Request for Change Order

La Vernia ISD 2023 Bond Projects (**231091**)

No. RCO0052

Description	PR#15 - JHS Area K Band Hal Raise	Date	2025-09-29
Status:	Pending Review	Days Impact:

12 K103 - MULTIPURPOSE - WEST
SCALE: 1/4" = 1'-0"

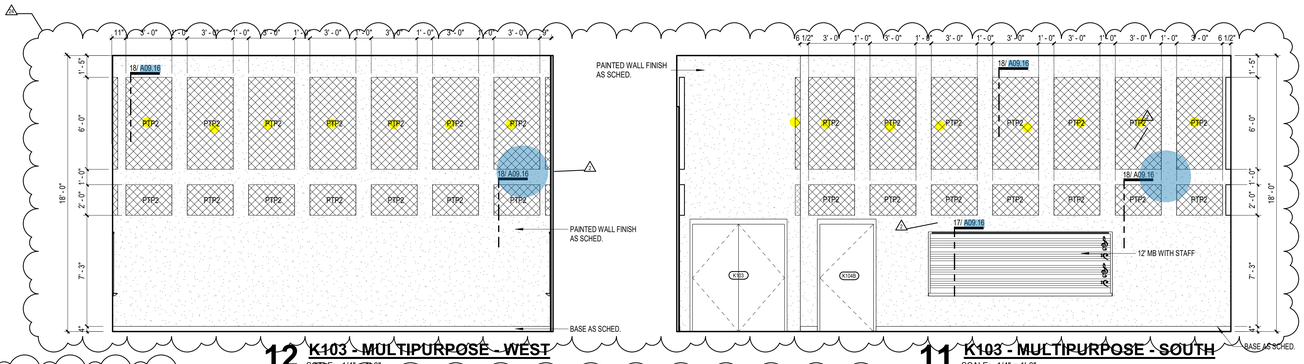
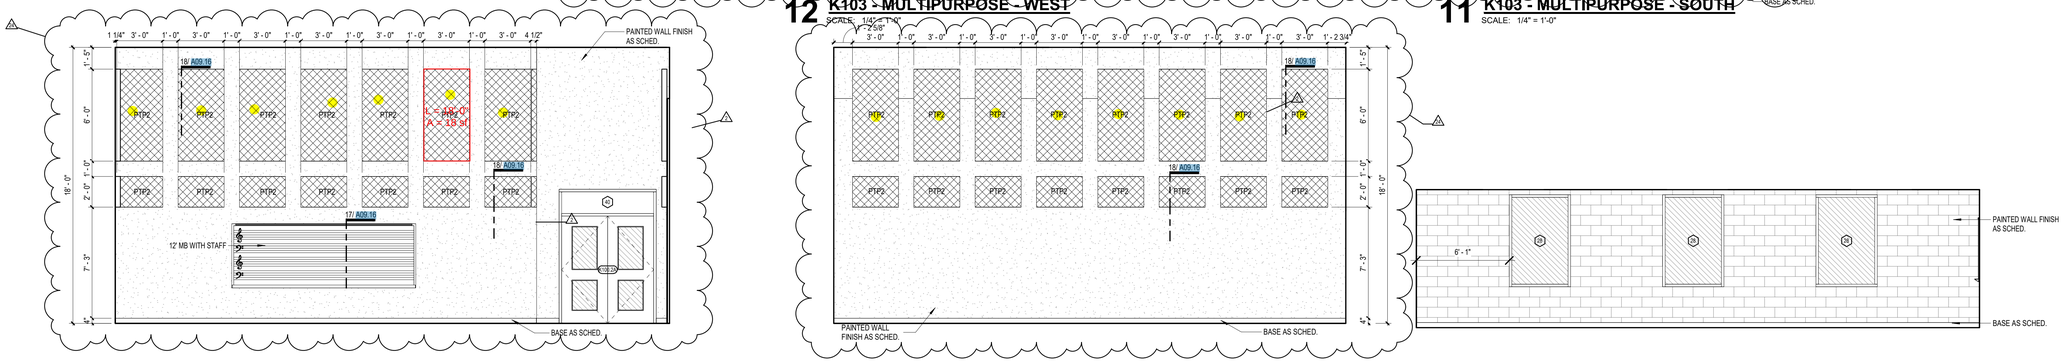
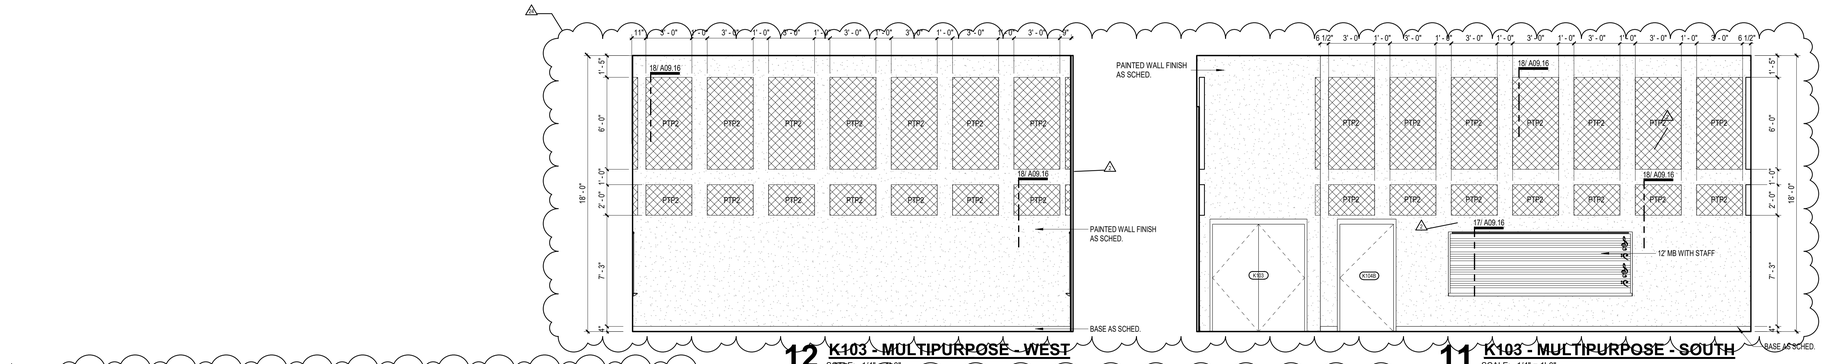
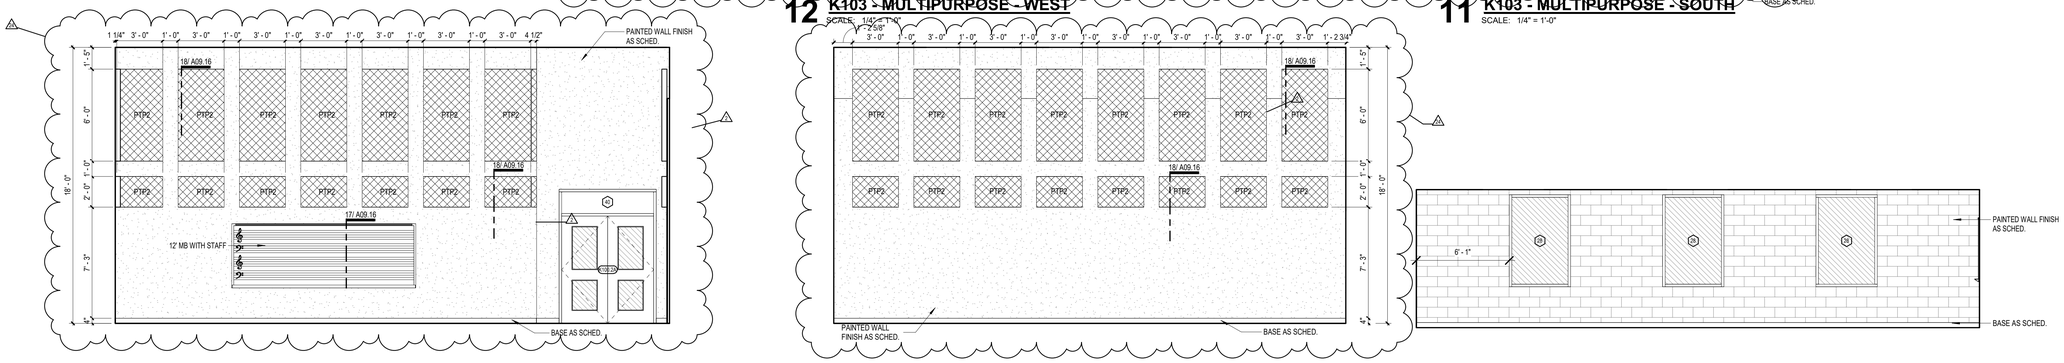
12. Add 3’ x 6’ Tectum panels in the multi-purpose rooms K103 and K105.

60 new tectum panel 3'x6'
18LF per tectum panel perimeter
3LF per tectum panel interior
Blocking is (2) 2x4s per dimension
60*((18*2)+(3*2))=2,520LF
4.6 2x4x10s per tectum panel
276 2x4x10s required for all tectum panels

1 LEVEL 01 - FLOOR PLAN - SEG K - JHS BLDG 500/600
SCALE: 1/8" = 1'-0"

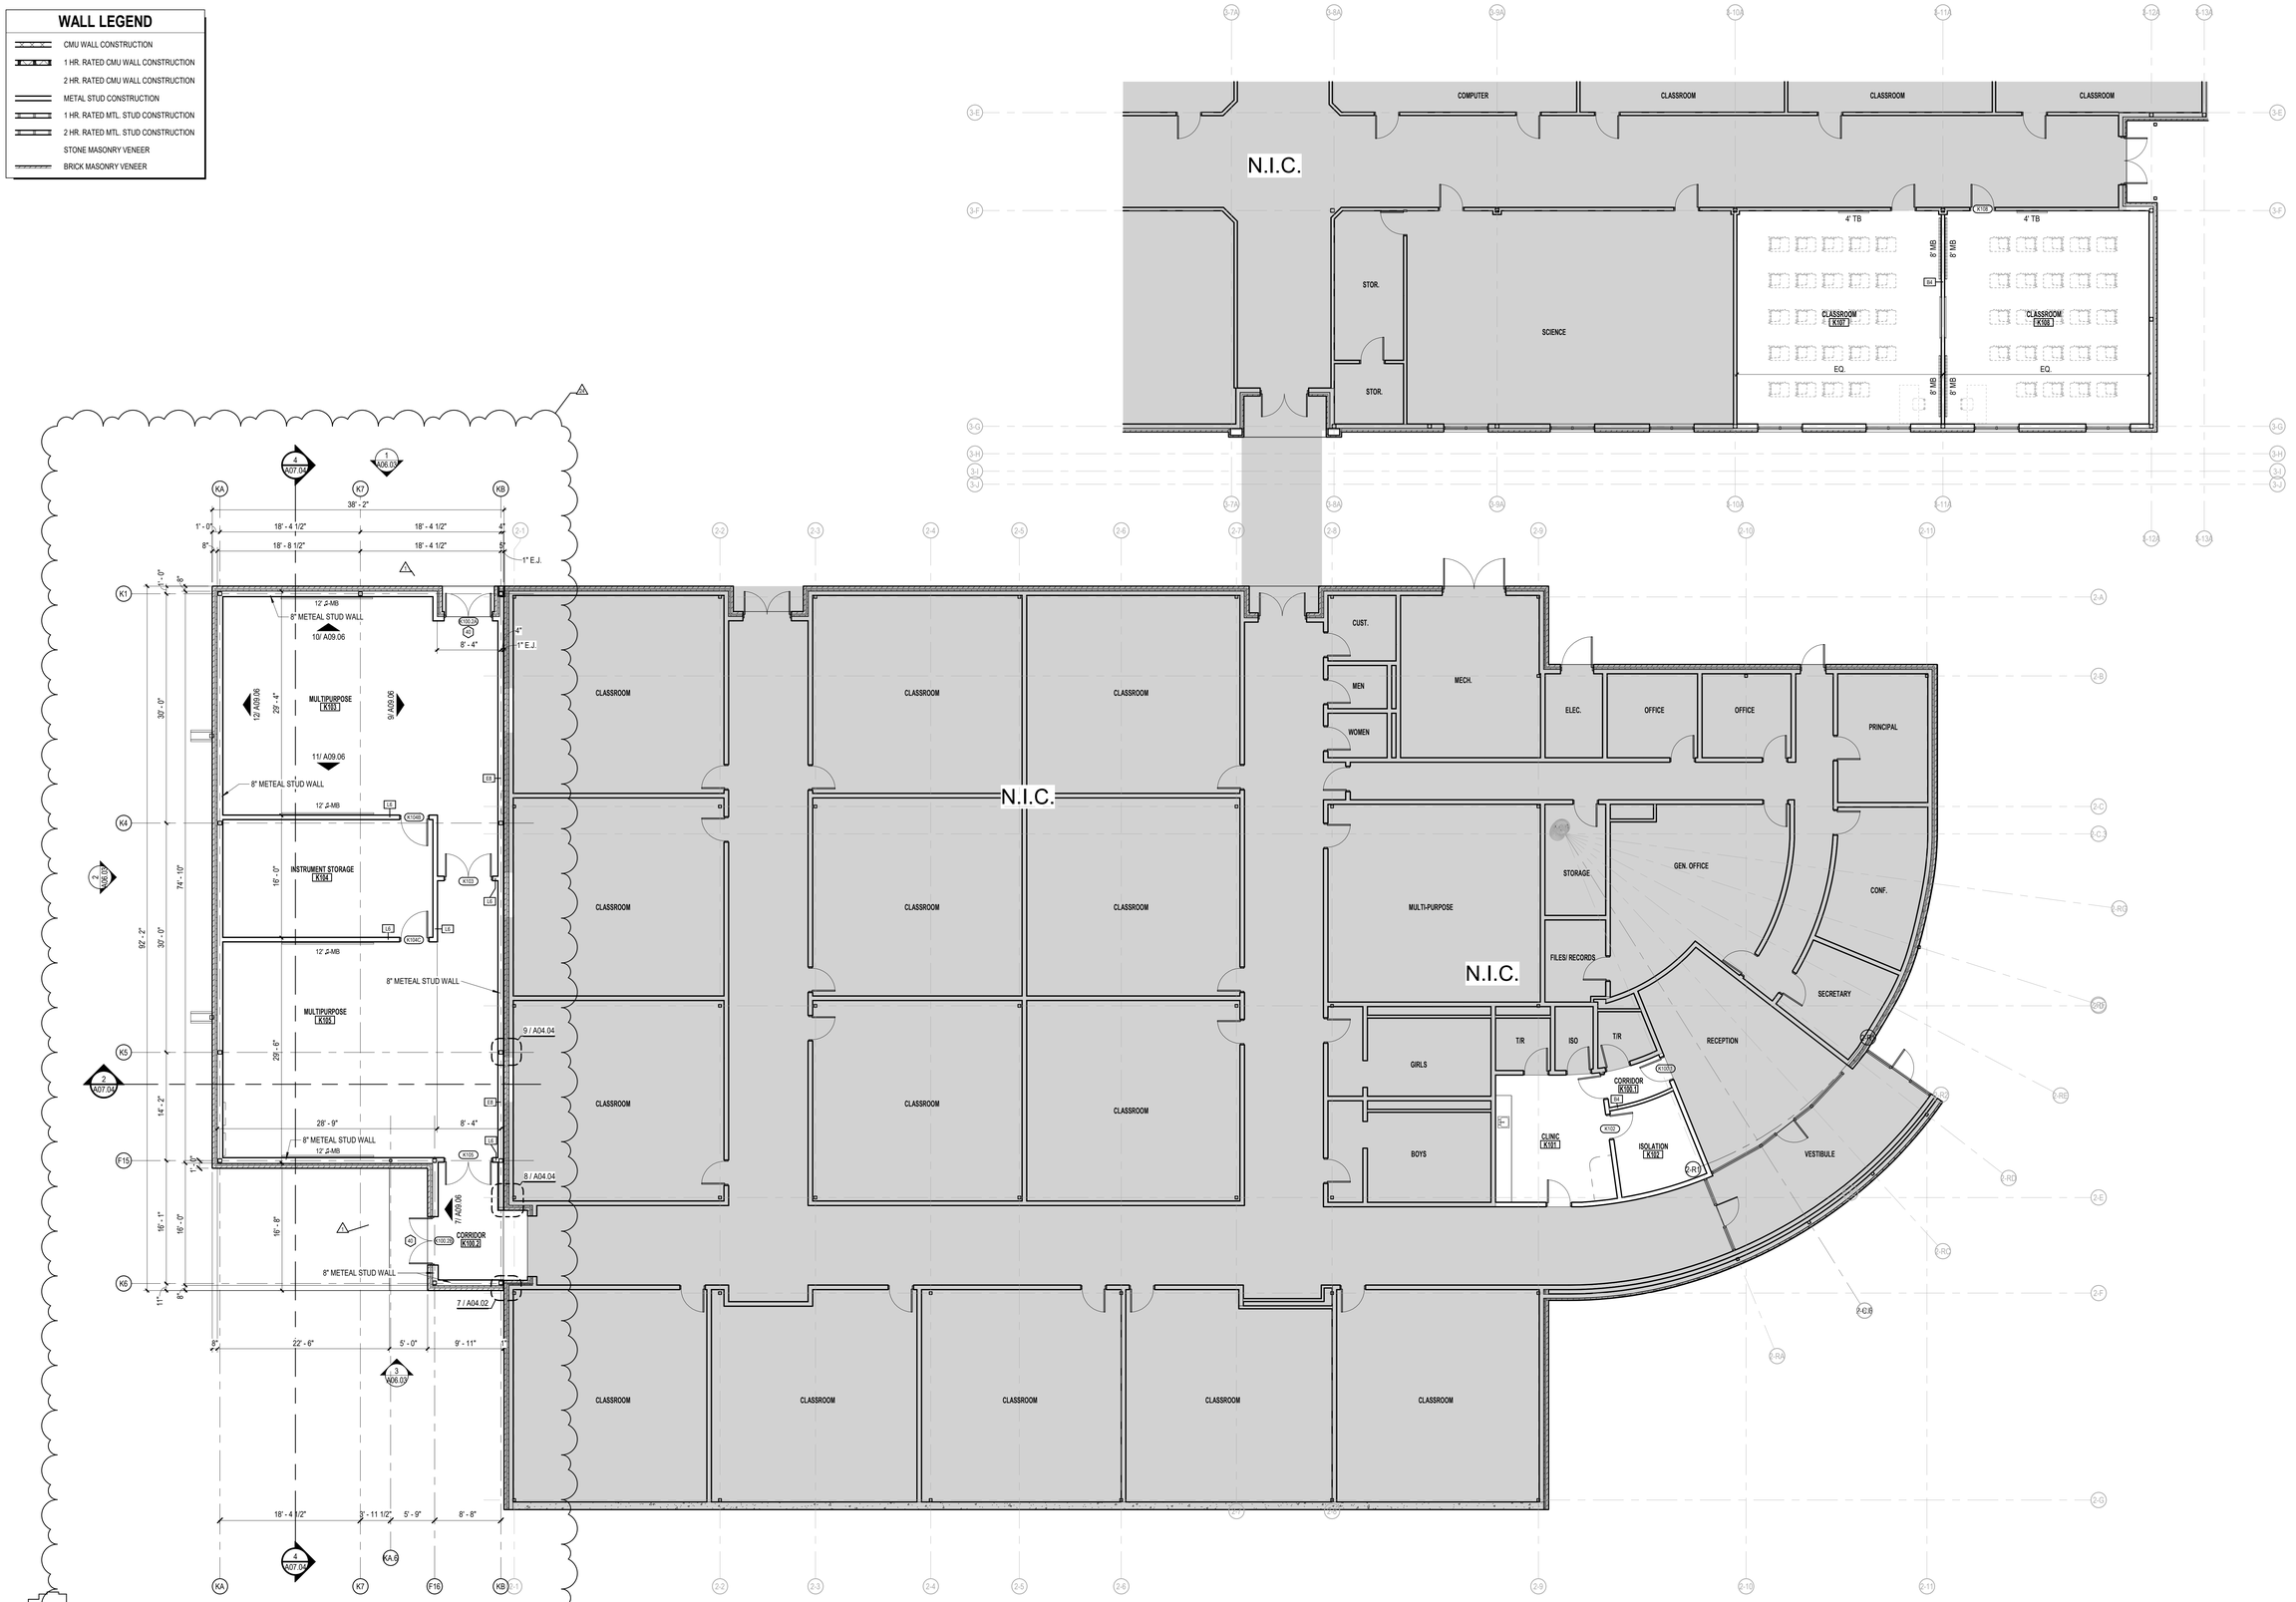
2. Provide credit for the L6 wall types removed on sheet A02.01K.

1 FOUNDATION FRAMING PLAN - SEG. K BAND ADDITION

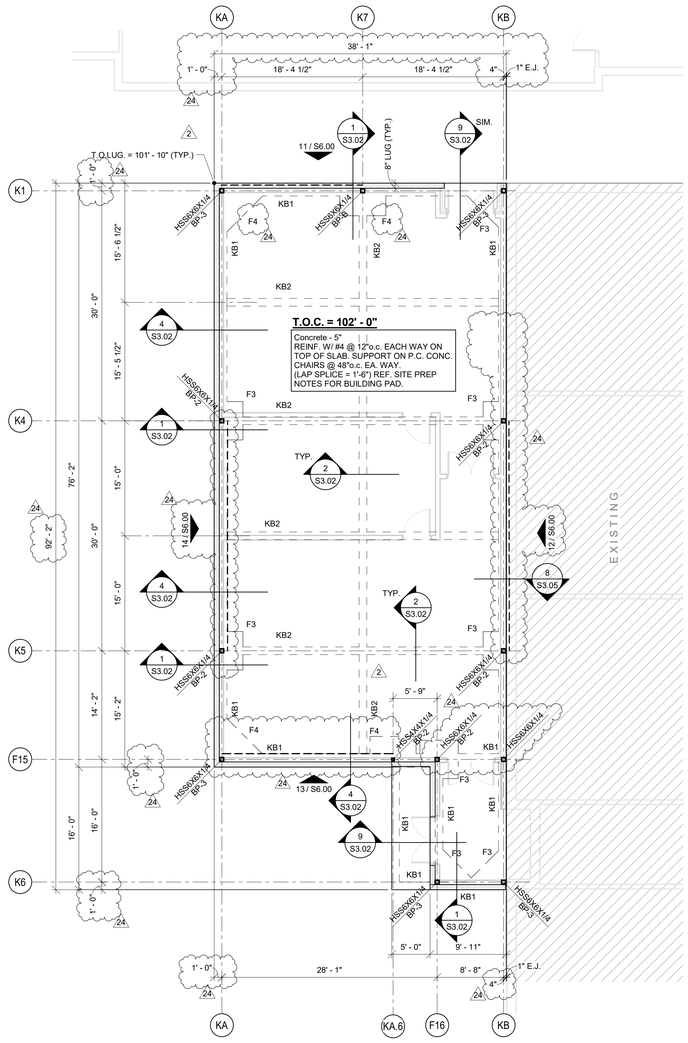
5M Concrete: Upsized concrete footings and beams.

ADD CONTINUOUS #3@12"o.c. HORIZONTAL BARS AT EA. FACE AND #3 STIRRUPS @ 12"o.c. WHEN BEAM DEPTH BECOMES DEEPER THAN 36" DUE TO LOWER FINAL GRADE (TYPICAL).

1 ROOF FRAMING PLAN - SEG. K BAND ADDITION
SCALE : 1/8" = 1'-0"

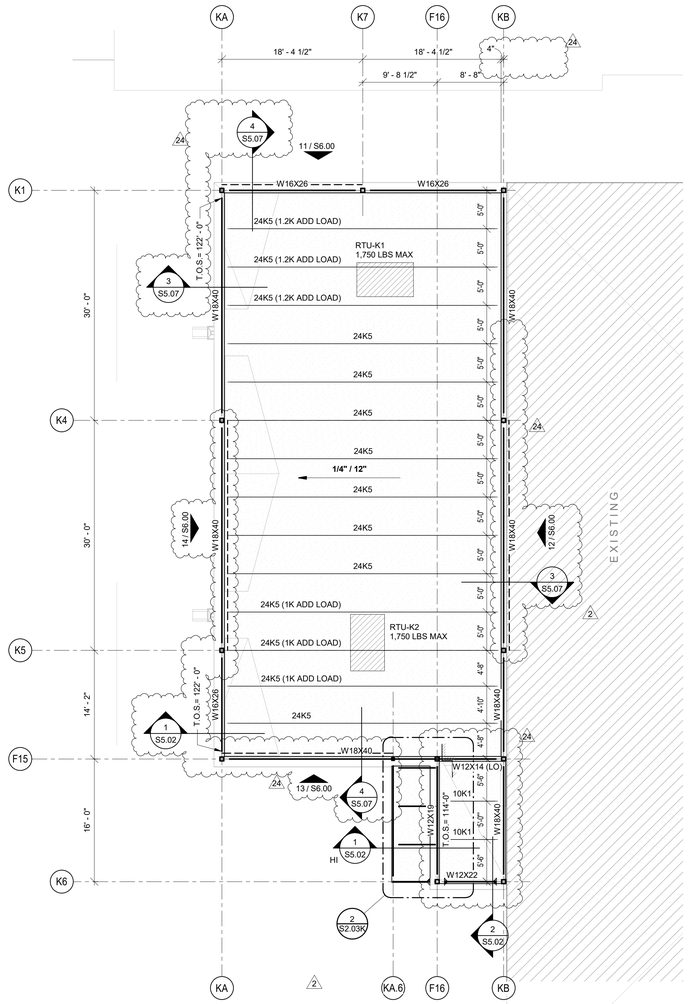
Yes, you are correct. All the columns except two were lengthened by 8 feet, all the brace bays were added on to be double braces instead of singles and a WF beam was added near the canopy. Also, sections 3 and 4 on S5.07 were added that included steel for a parapet wall around the building. We were able to use all the steel we had on hand and the additional brace material we did not have on hand yet. Let me know if you need anything else in regards to this PR.

2 RCP - LEVEL 01 - SEG K - JH BAND HALL ADDITION - LIGHTING
1/8" = 1'-0"

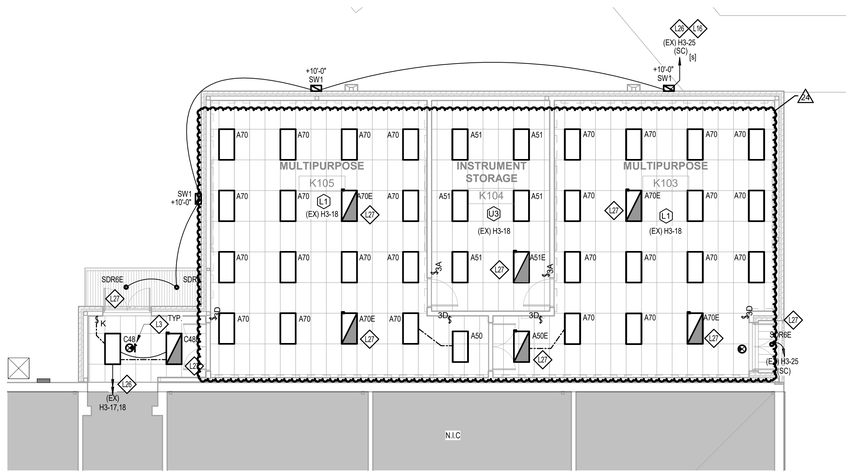
E2.1K – FLOOR PLAN – LEVEL 01 – SEG. K – LIGHTING

1. Revise location of light fixtures and switch as shown on attached, revised sheet.

1 FLOOR PLAN - LEVEL 01 - SEG K - JH
BAND ADDITION - POWER
1/8" = 1'-0"

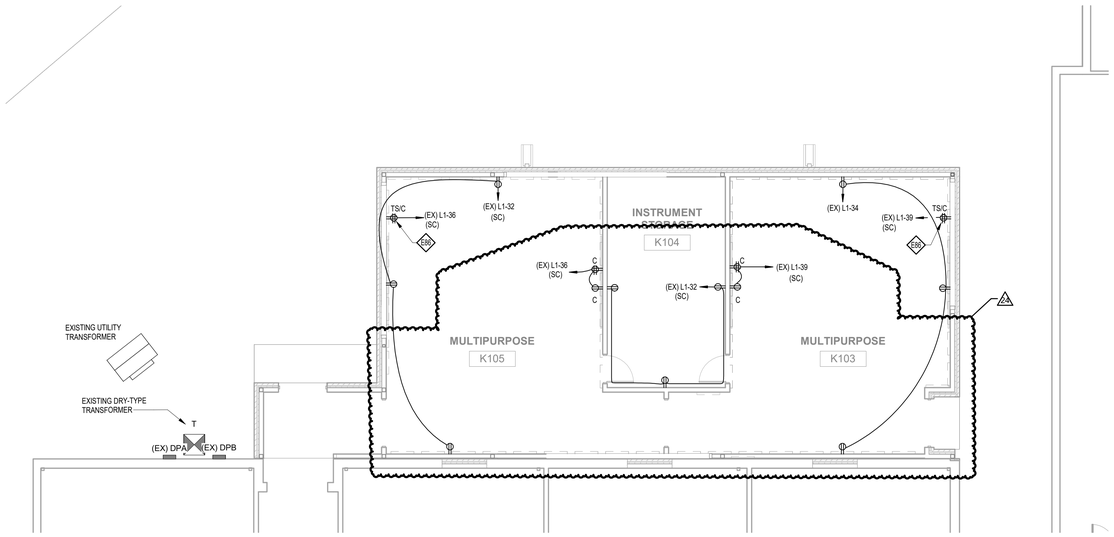
E3.1K – FLOOR PLAN – LEVEL 01 – SEG K – POWER

1. Revise location of receptacles as shown on attached, revised sheet.

1 JUNIOR HIGH BAND ADDITION - HVAC
1/8" = 1'-0"

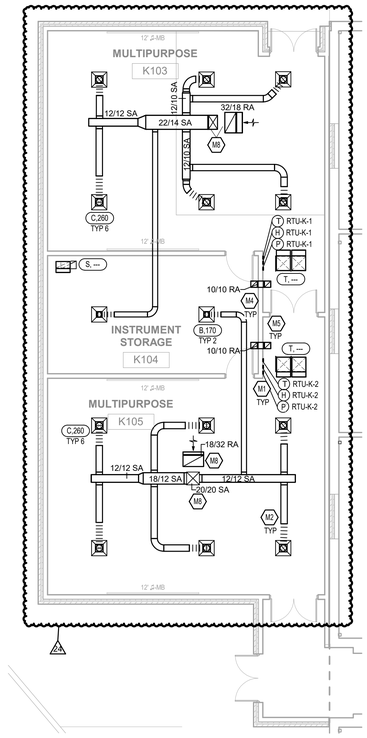
1. Revise supply CFM and outside air CFM for RTU-K1 & RTU-K2.

M2.1K – FIRST FLOOR PLAN – SEGMENT K – HVAC

2. Revise ductwork routing and air device locations.
3. Revise transfer duct locations.
4. Revise sensor locations.
